MARCH 25, 2024

ADDENDUM NO. 1

TO CONSTRUCT **BIRKHIMER EMERGENCY OPERATIONS CENTER (EOC)
UPGRADES AND IMPROVEMENTS
PROJECT NO.: CA-202313-C
TAX MAP KEY: 3-1-042:600
Honolulu, Oahu, HAWAII**

SCALE: AS NOTED
STATE JOB NO. CA-202313-C
FEDERAL PROJECT NO. -
SHEET 9 OF 123
CS501

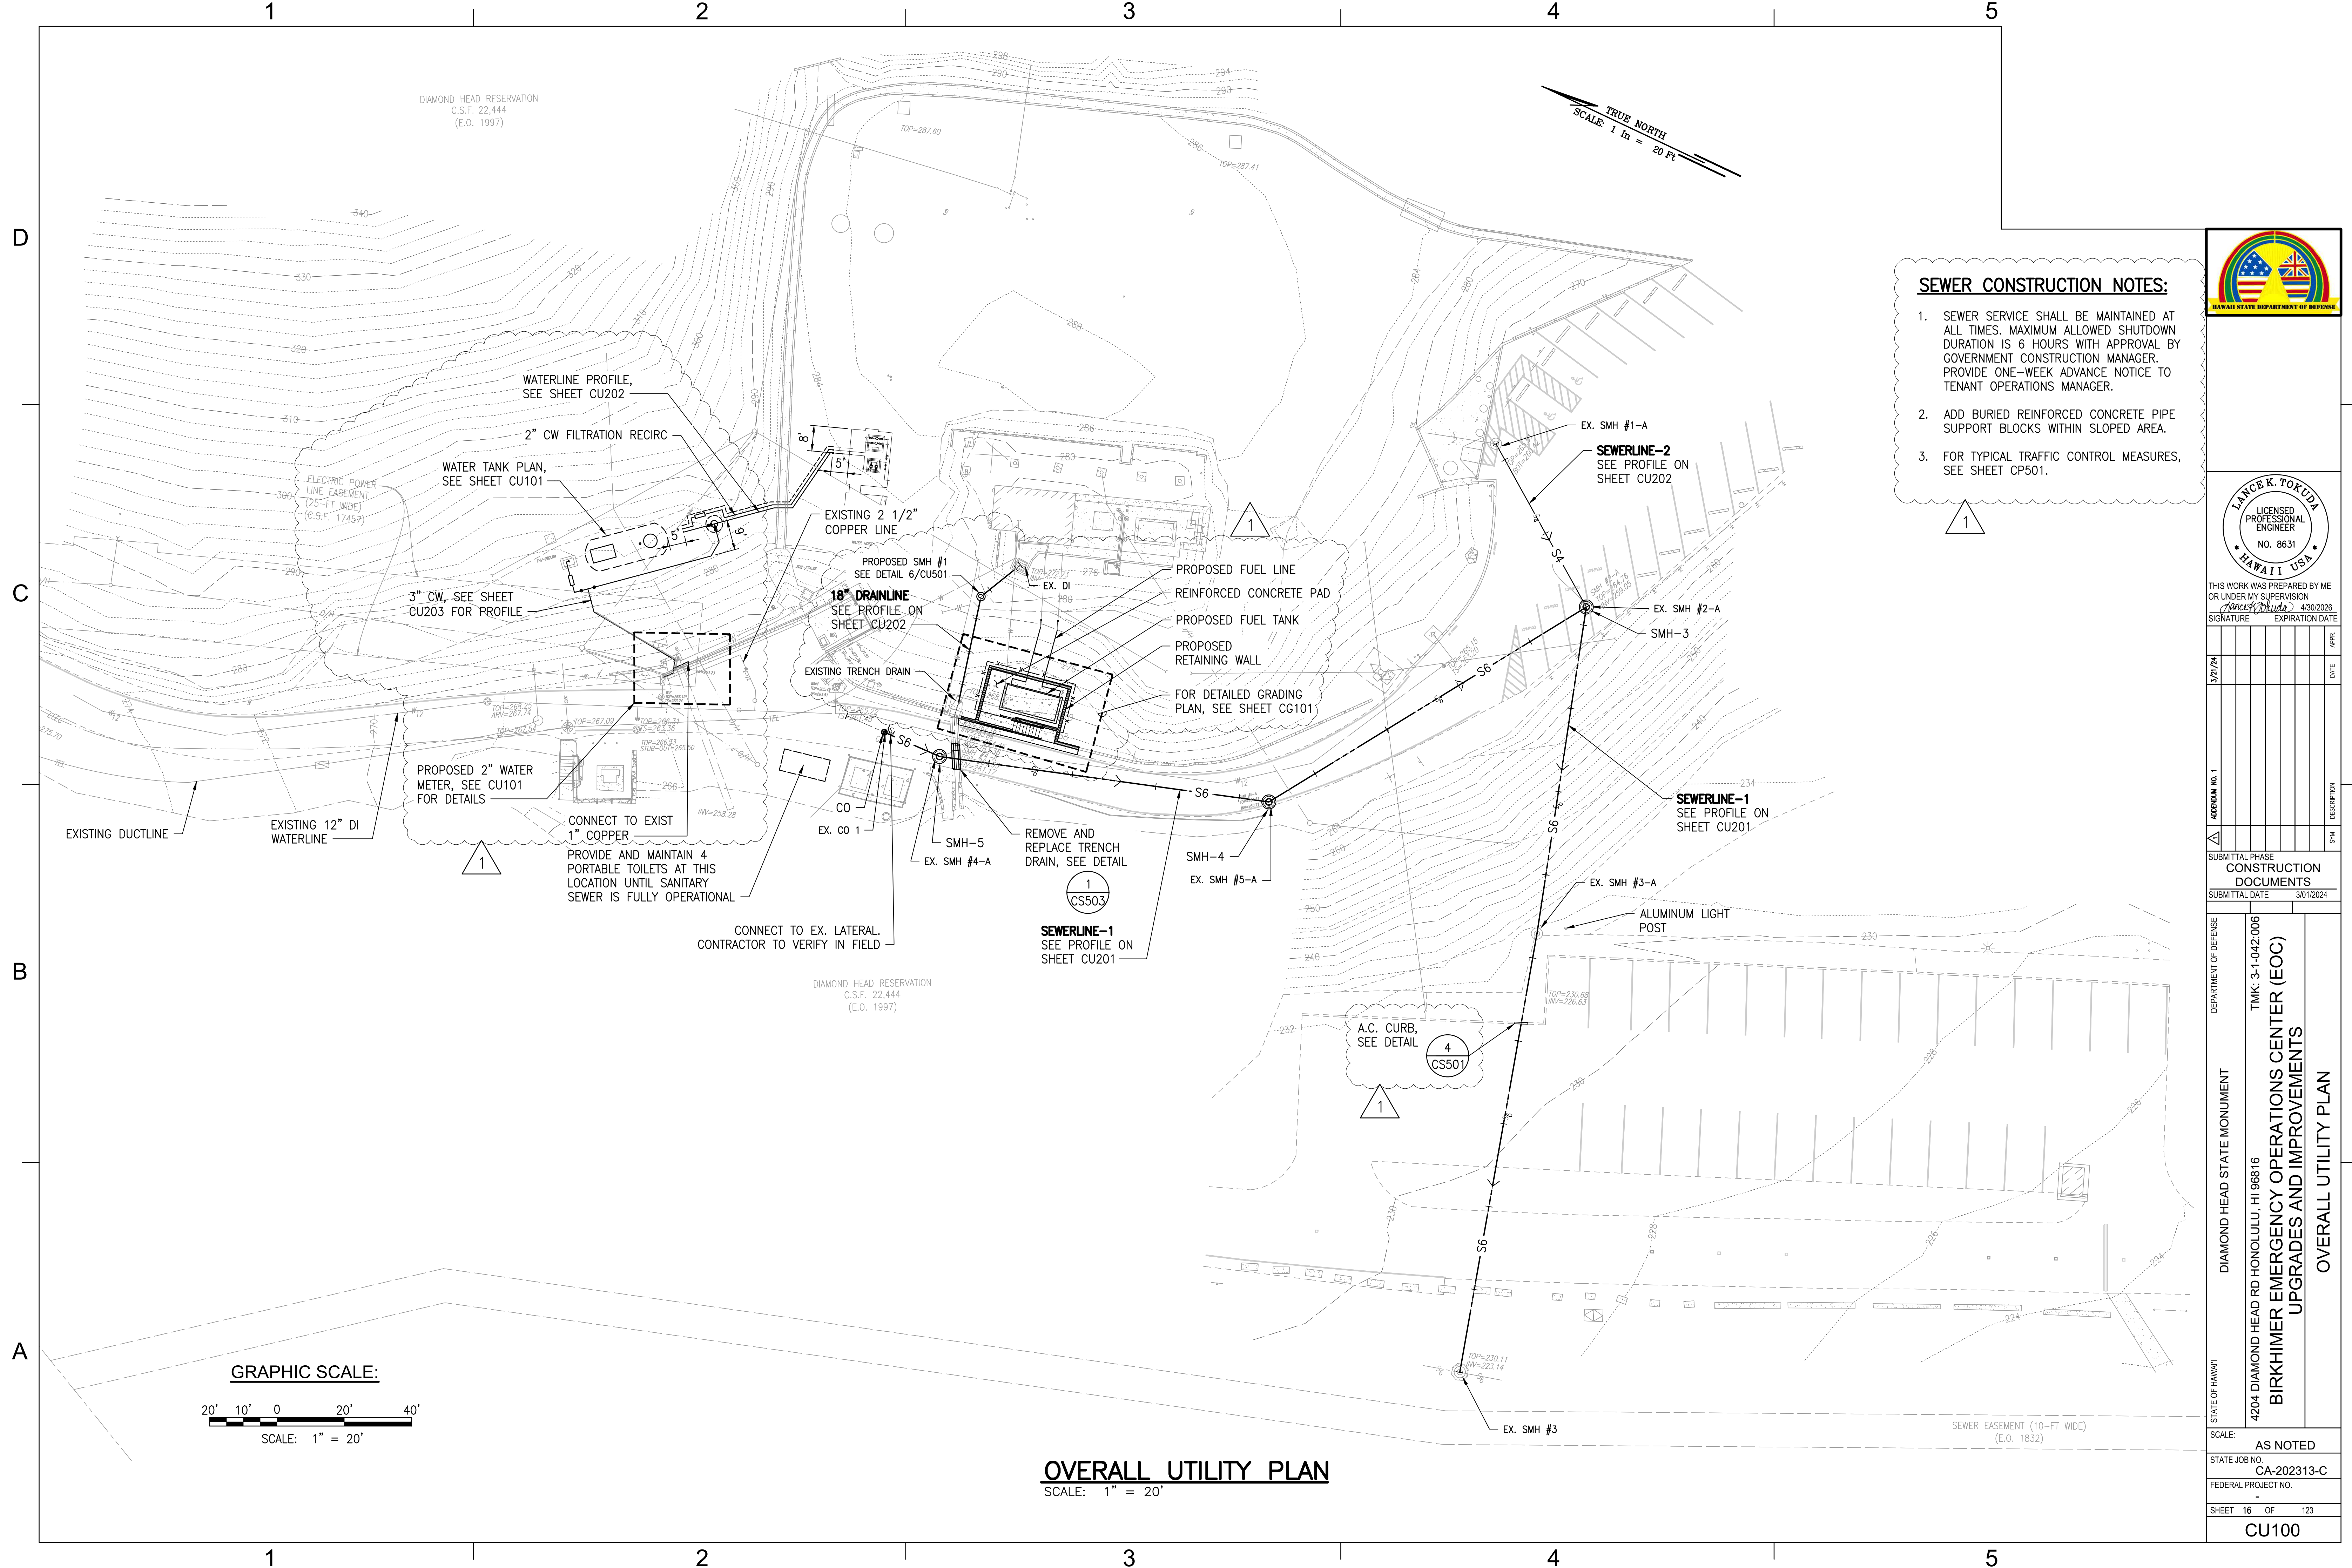
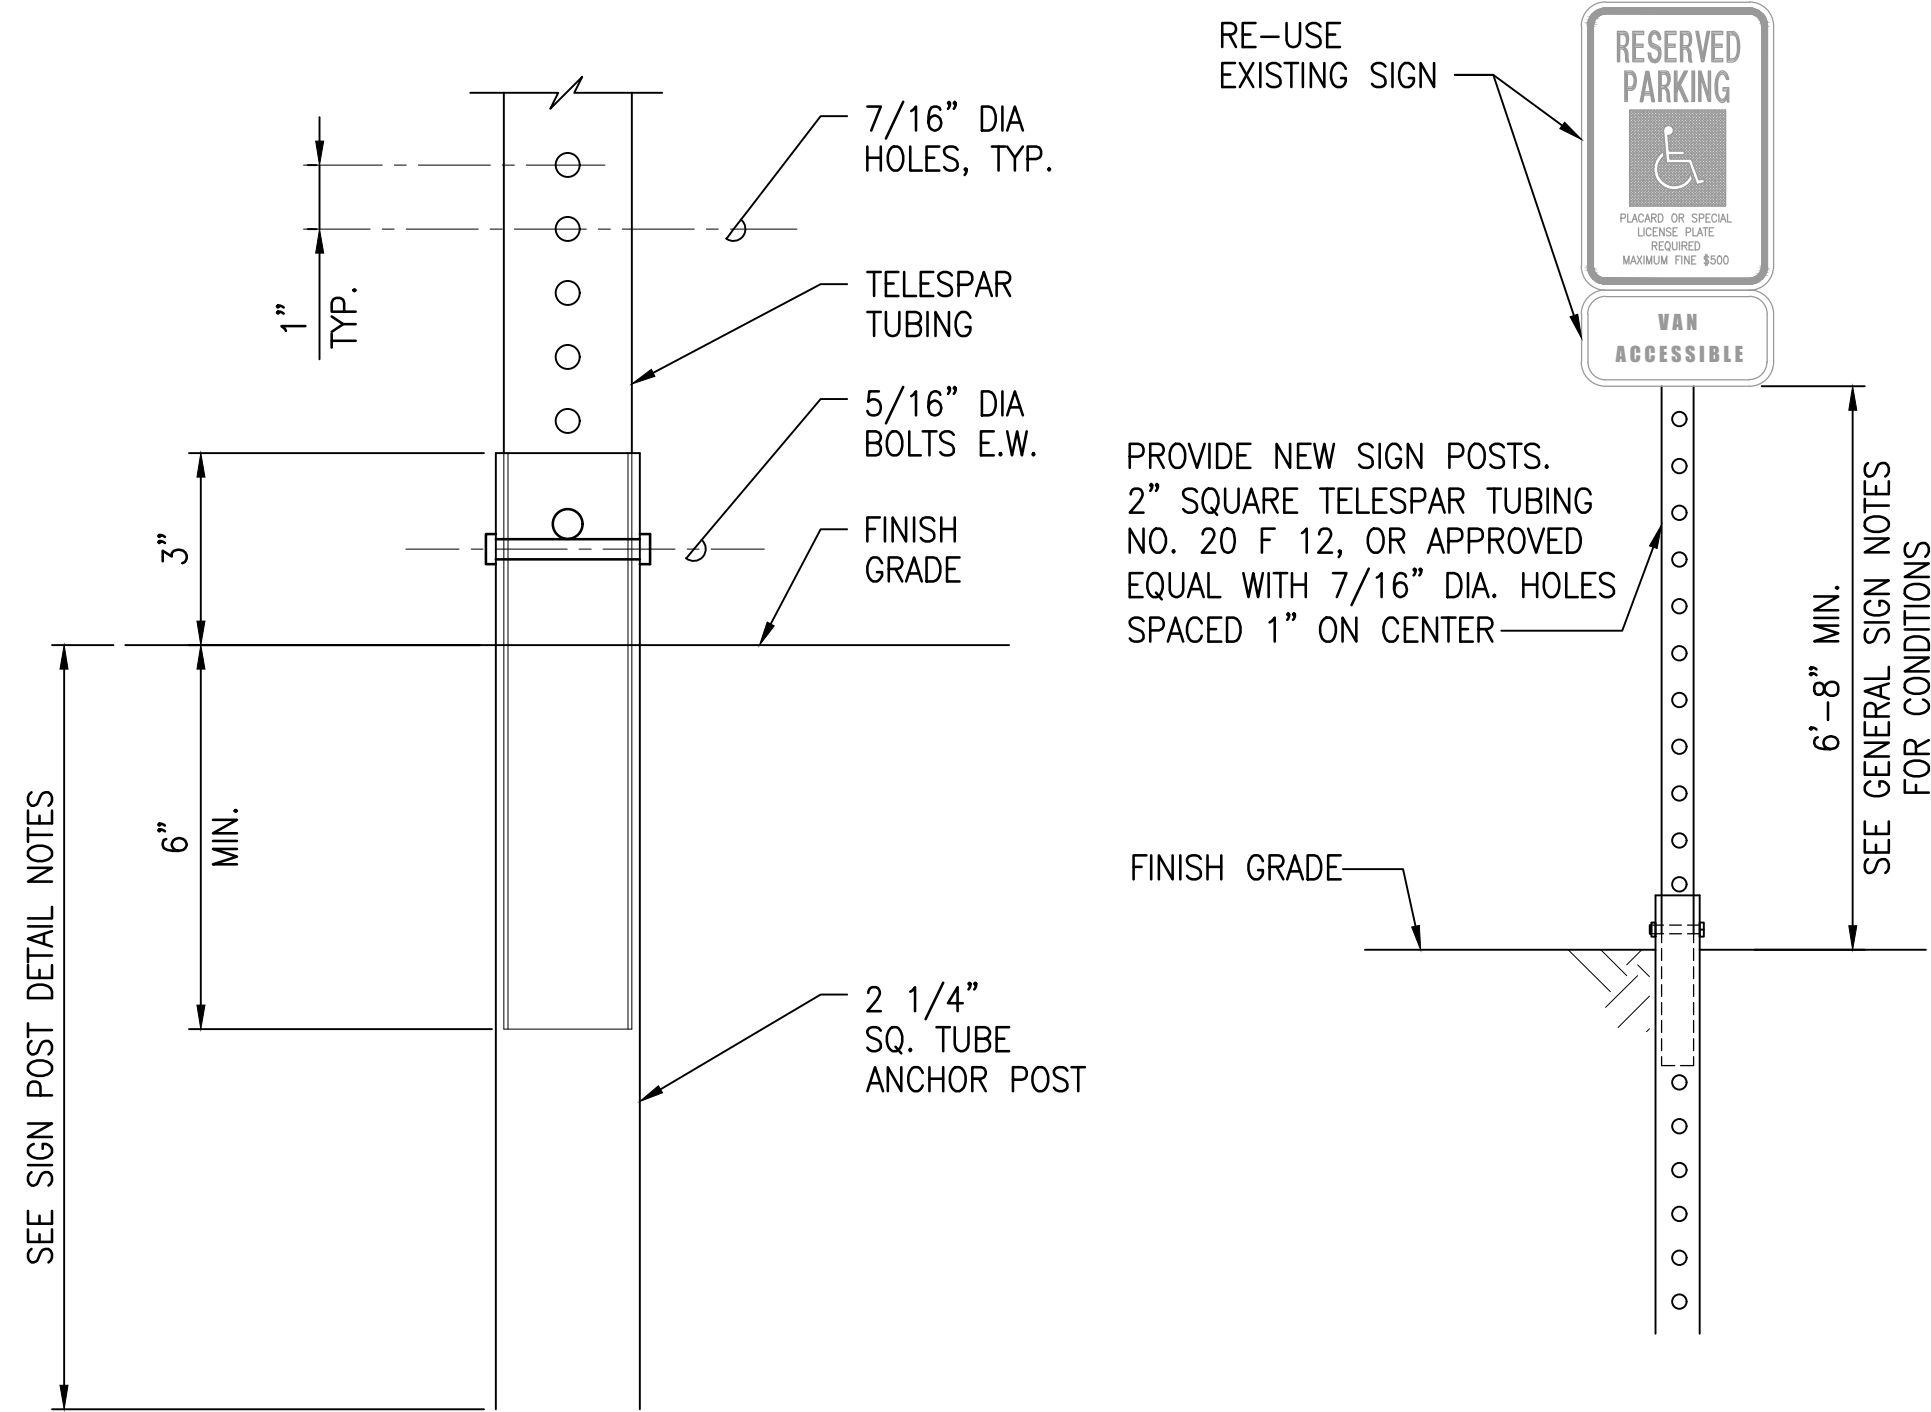
CIVIL	CS501	Add pavement structure detail Added wheel stop detail Added sign post detail Added stair detail
CIVIL	CS502	Revised gate detail to pedestrian gate
CIVIL	CG101	Revised tank location and retaining walls Elevate platform and added concrete steps
CIVIL	CG301	Revised platform elevation and retaining walls
CIVIL	CG302	Revised wall elevation
CIVIL	CP502	Revised paving limits
CIVIL	CU100	Shift fuel tank location north Revised 3" waterline alignment
CIVIL	CU100	Revised 3" waterline alignment Added backflow preventer on Waterline 1 Added backflow preventor on CWR line Added Detail A at water supply connection
CIVIL	CU202	Added drain line profile
CIVIL	CU203	Revised profiles
STRUCTURAL	S-101	Revised roof shoring note
STRUCTURAL	S-501	Revised repair notes
MECHANICAL	MB102	MECHANICAL ROOF PLANS Revised location of ACCU-2.
MECHANICAL	MB202	ENLARGED FLOOR PLAN AREA 2_5 – DEMO Revised note to temporarily remove the door frame for the closet serving AHU-2 during construction.
